Subject: Final Rule, Response to Petitions for Reconsideration, Technical Amendment, Docket No. 2008-0111, Anthropomorphic Test Devices; ES-2re Side Impact Crash Test Dummy 50th Percentile Adult Male.

First Technology Safety Systems (FTSS) has reviewed the February, 2008, ES-2re dummy drawing package (identified in the above mentioned technical amendment) and we have identified a number of drawing errors and a number of drawing issues. We seek to petition NHTSA to correct these drawings to ensure that the ES-2re dummy continues to meet the same dimensional and performance requirements established for the dummy when the dummy was proposed for inclusion into 49 CFR Part 572 Subpart U. FTSS makes the following comments and recommendations with respect to the drawing package. A marked up drawing for each of these recommended changes are attached to the end of this letter.

SECTION A-A

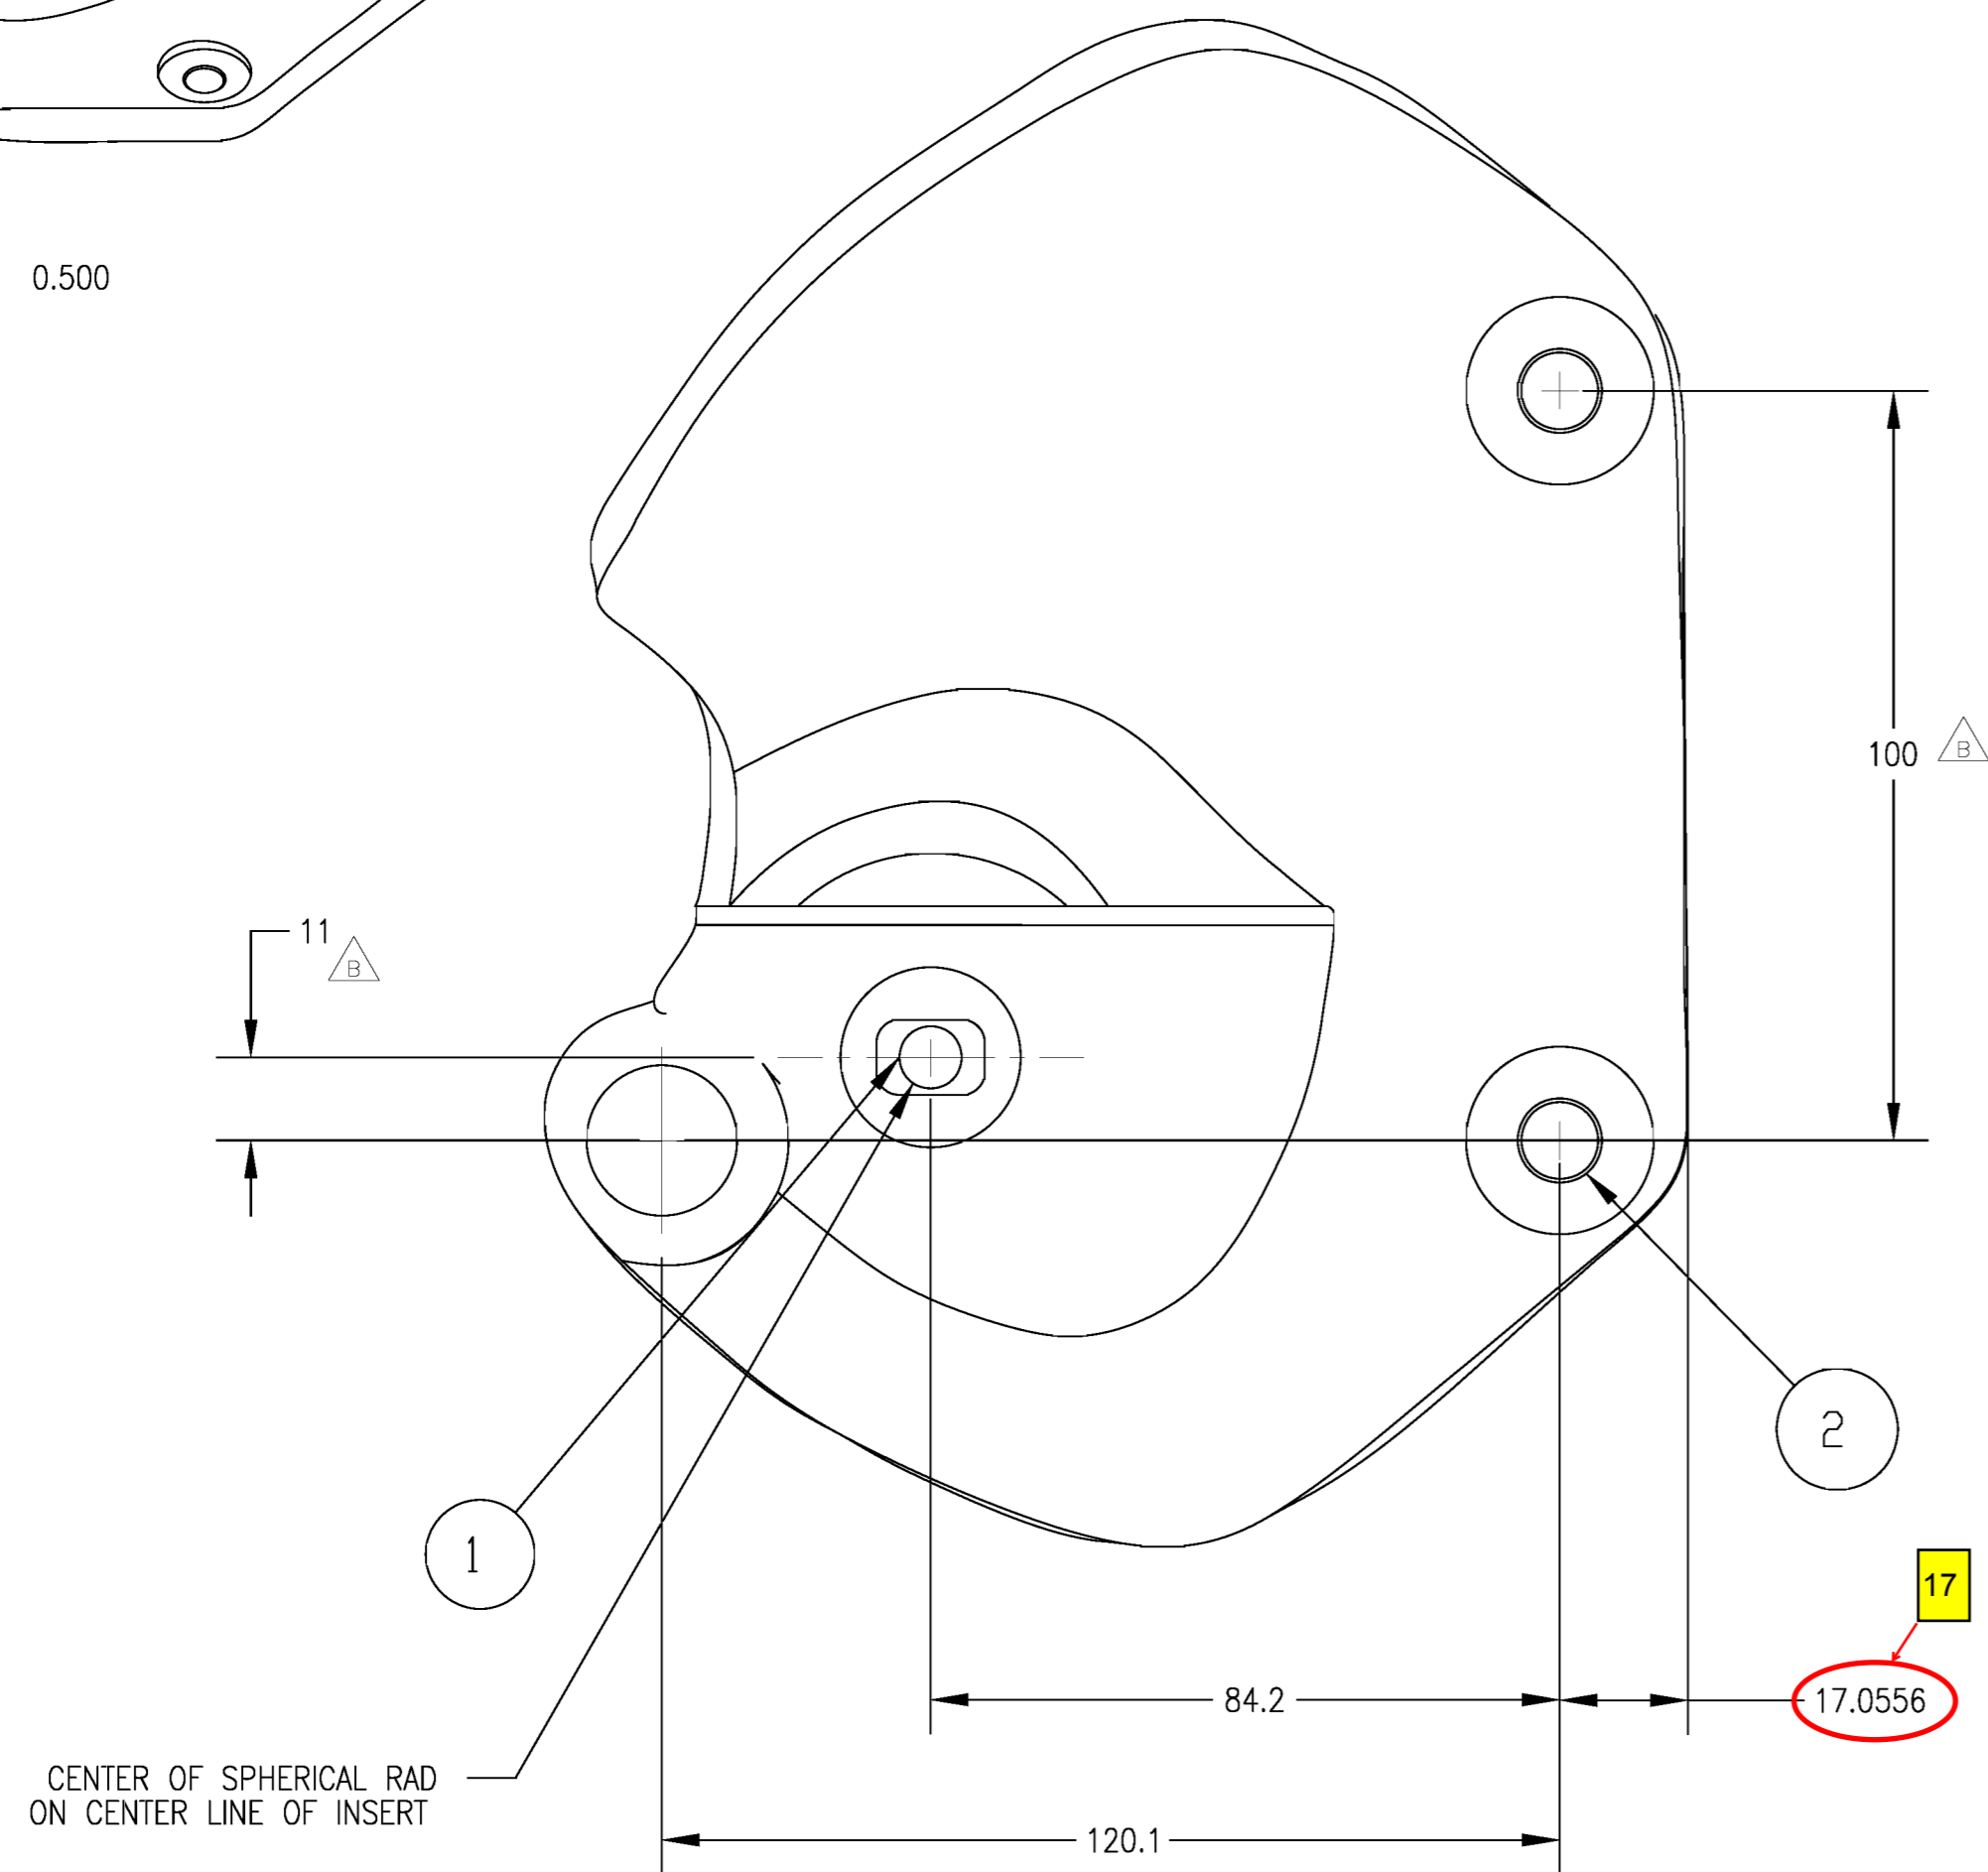
- 5) Drawing 175-6010, Iliac Wing Assembly, Left. Fix typographical error for drawing dimension "17.0556". This dimension should be "17" since it is not reasonable to control and measure this molded part to four decimal places and "17" also matches the same dimension as the Iliac Wing Assembly, Right (NHTSA Drawing 175-6002). FTSS also recommends that the drawing dimension "Ø20.03" be replaced with "Ø20.03 ± 0.10" since this dimension cannot be controlled to a tolerance of ± 0.05. We also recommend the addition of dimension "R0.5" to better define this location for easier machining of this particular section of the part and to prevent breakage due to concentrated stresses.

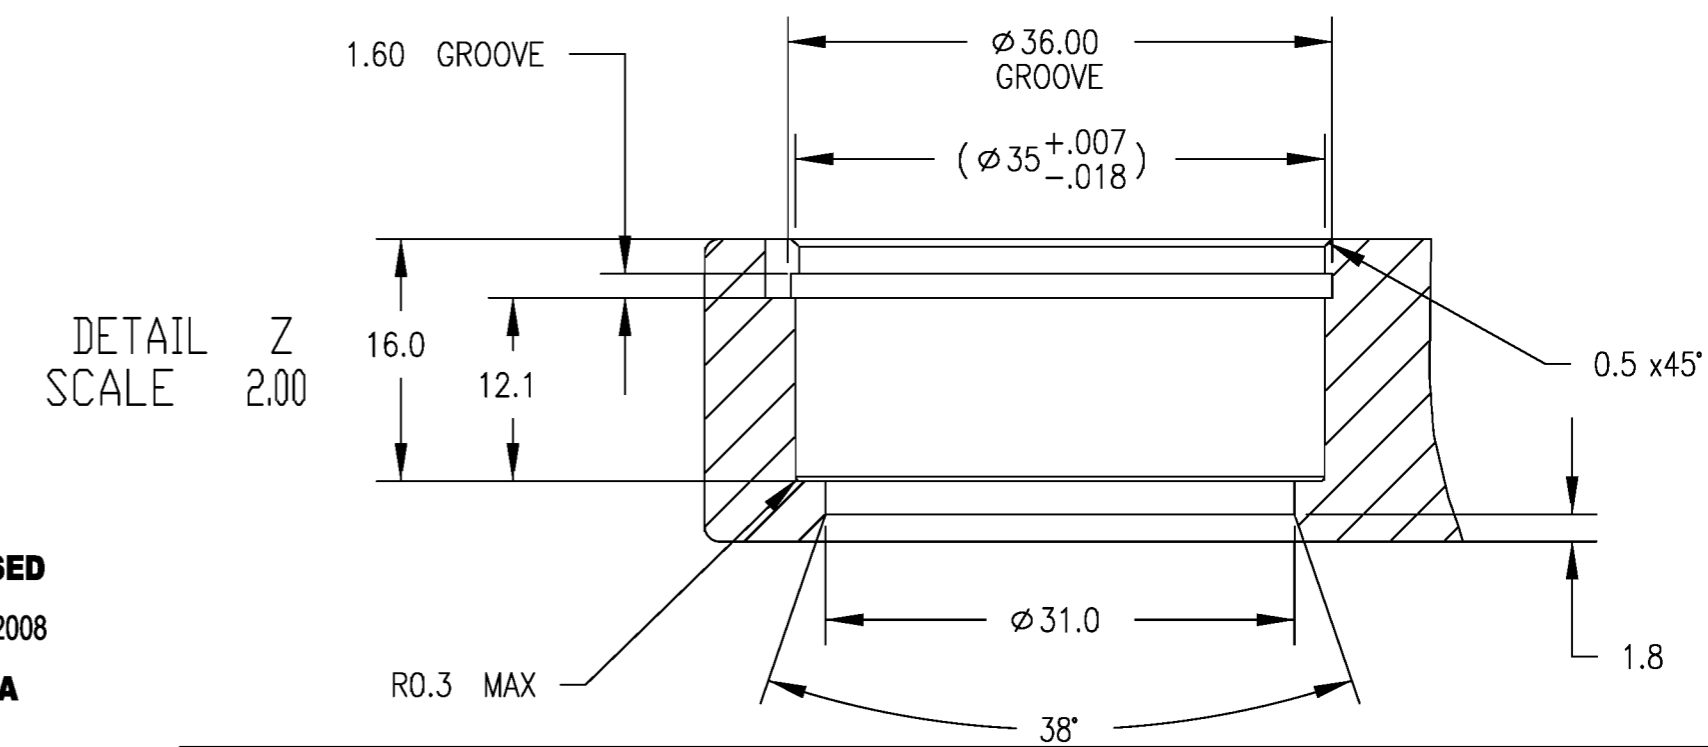
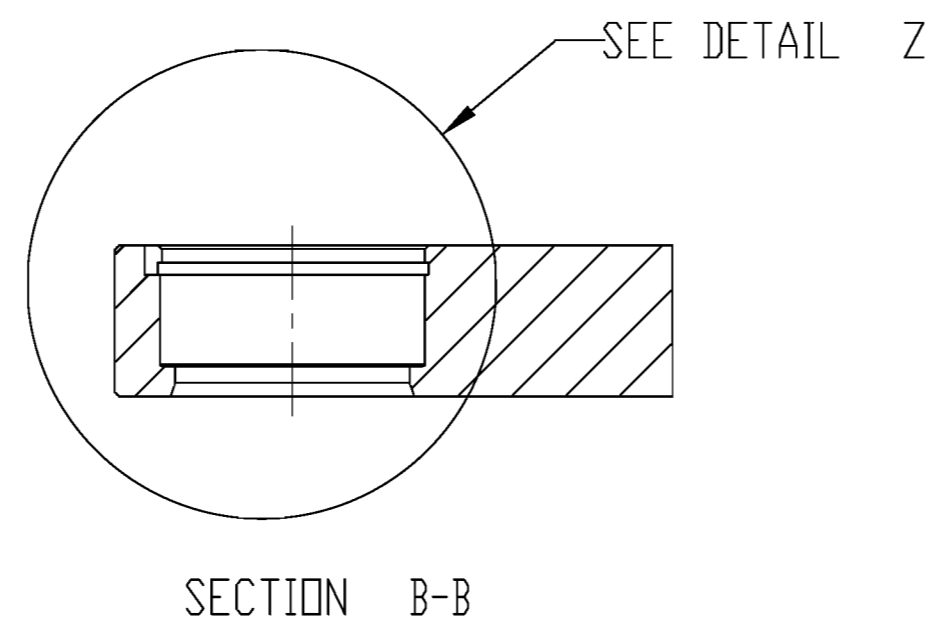
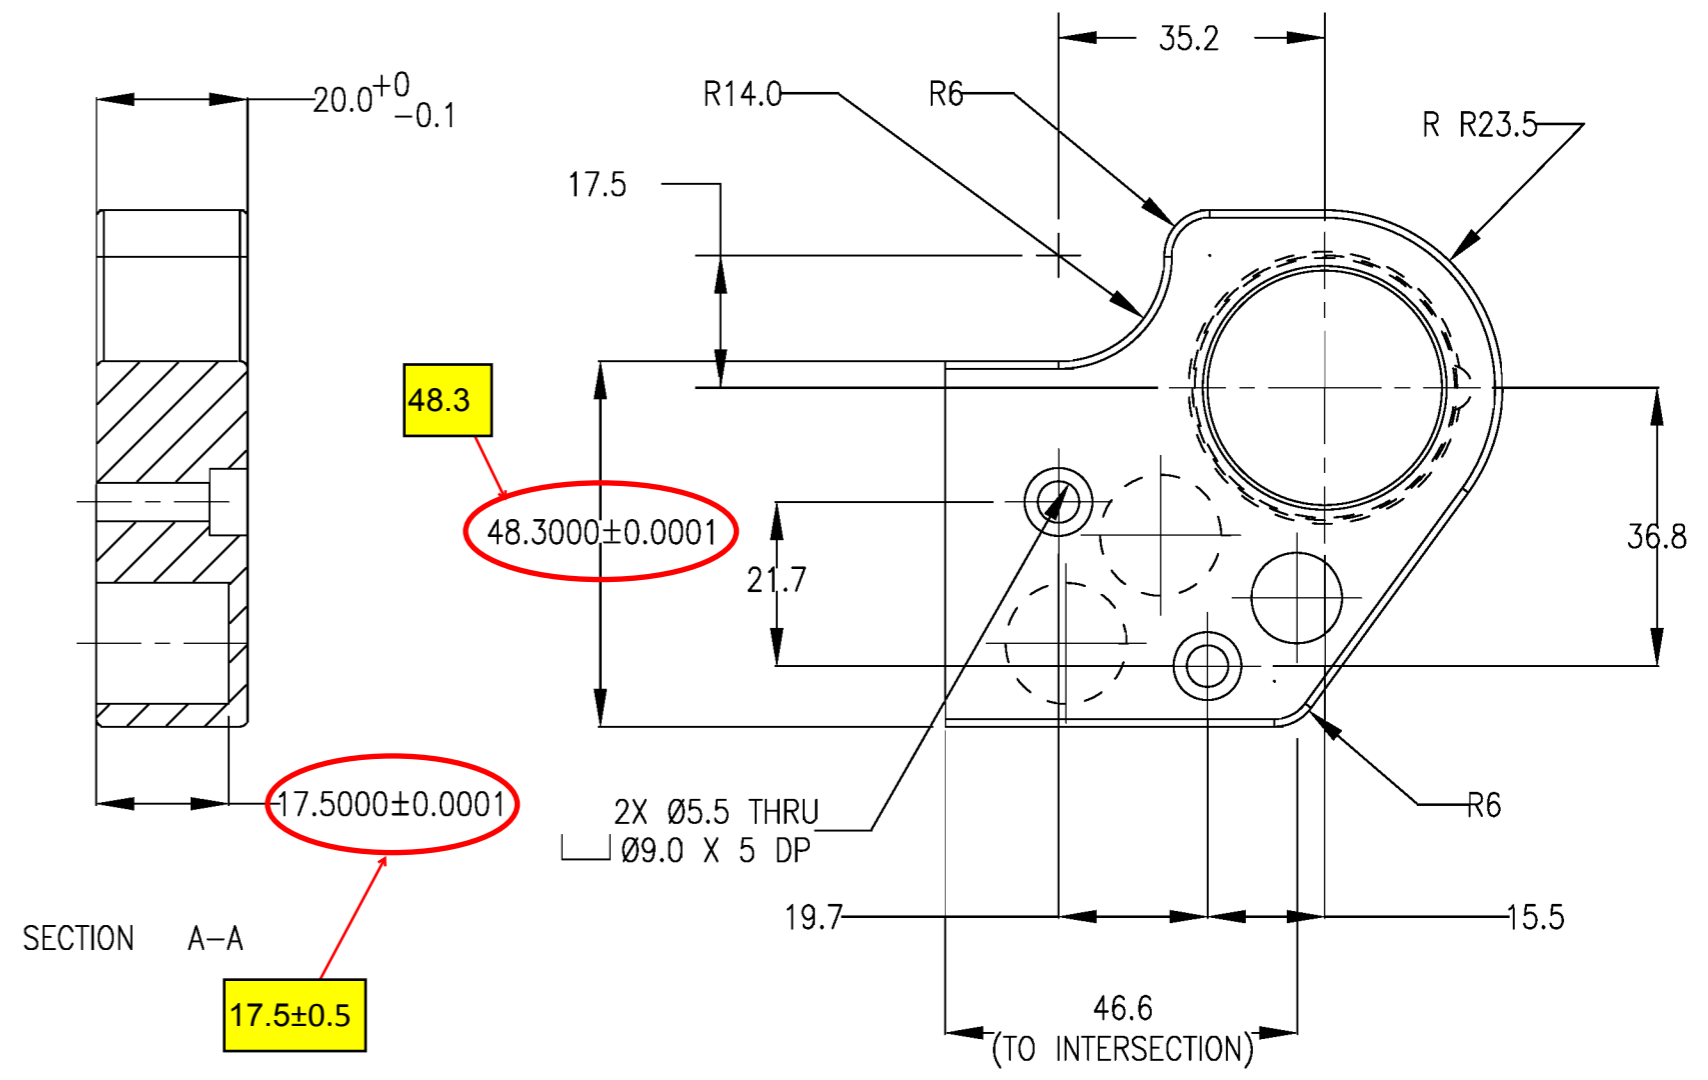
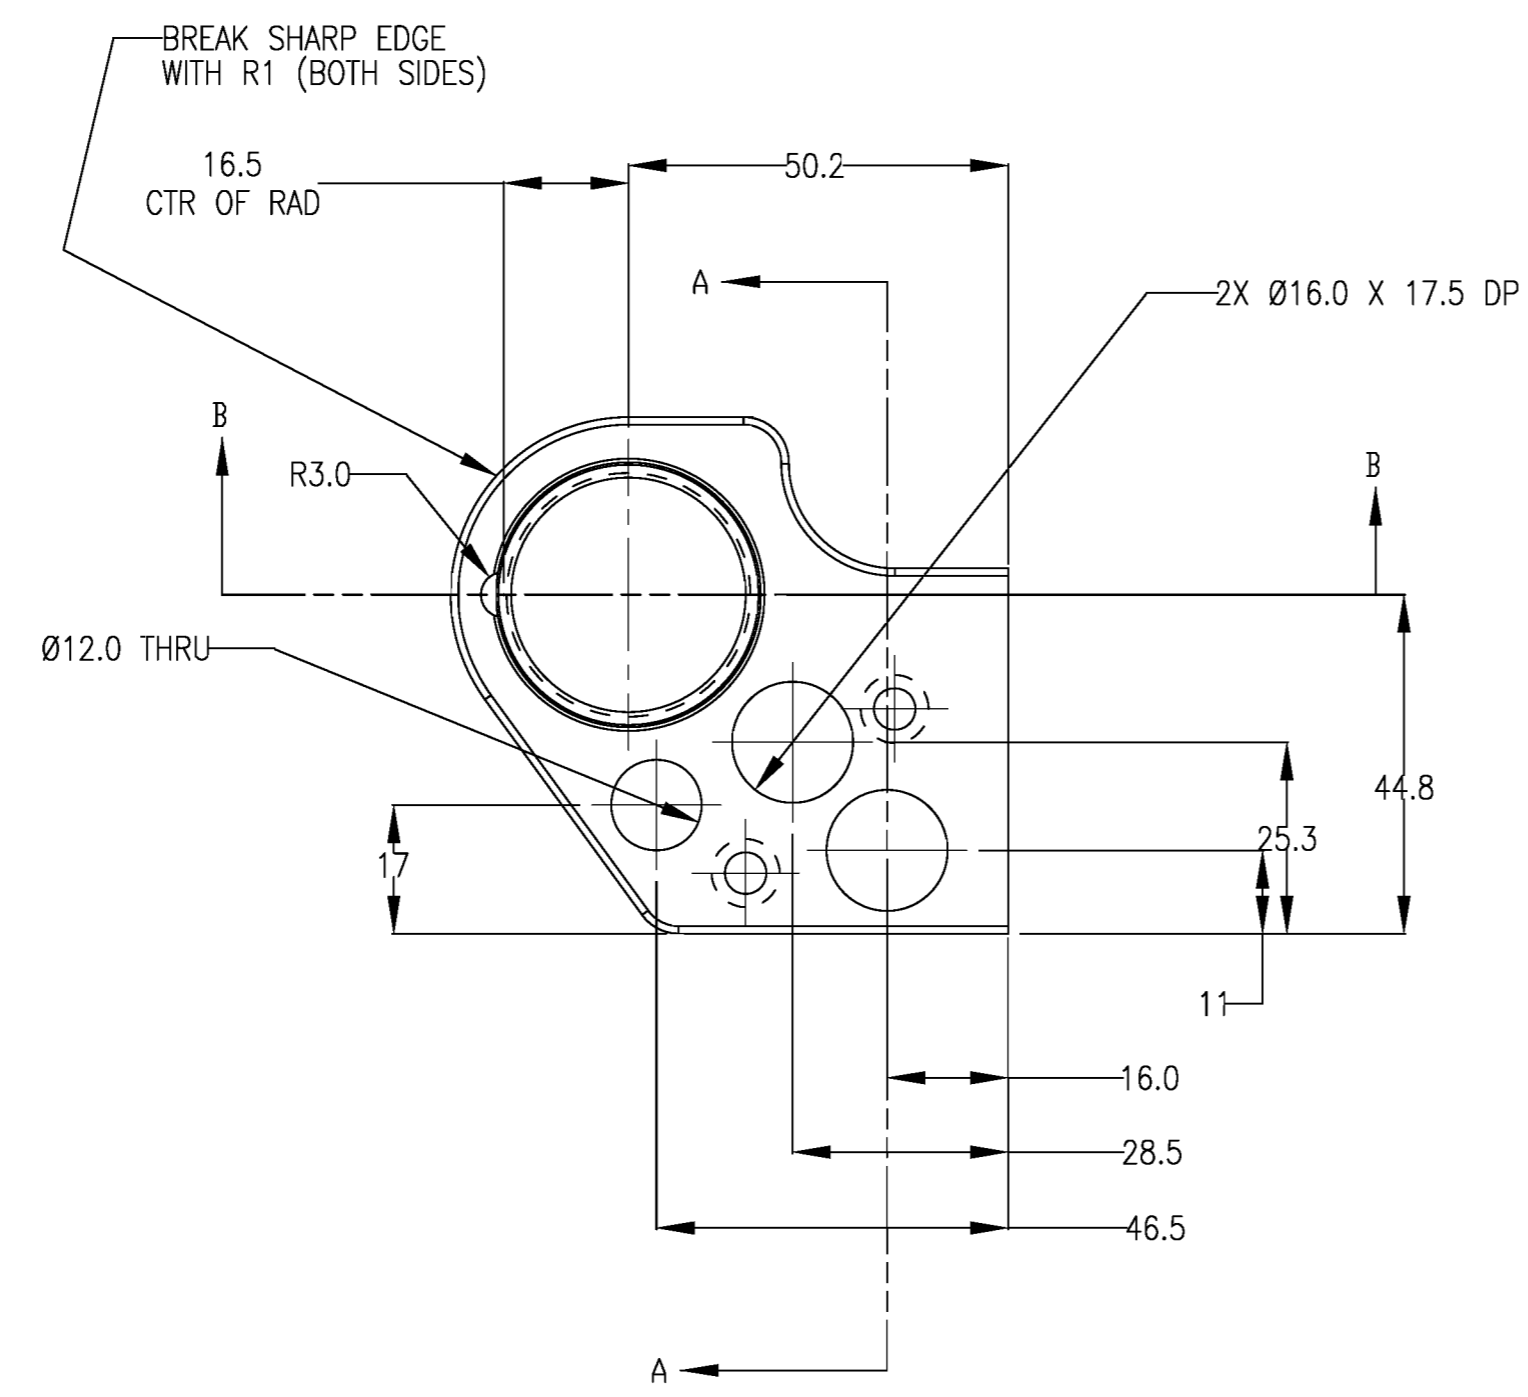
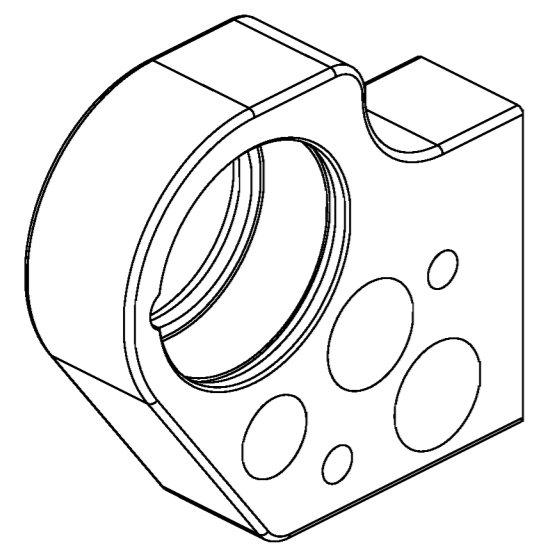
- 6) Drawing 175-6063, Femur Bearing Plate, Left. Fix typographical errors for drawing dimensions 17.5000 ± 0.0001 " and 48.3000 ± 0.0001 ". The tolerances are too tight to reasonably achieve at four decimal places and would add unnecessary expense when making the part. FTSS recommends that these dimensions should be specified as 17.5 ± 0.5 " and 48.3 ". These recommended dimensions would also match the existing dimensions on the Femur Bearing Plate, Right (NHTSA Drawing 175-6068).
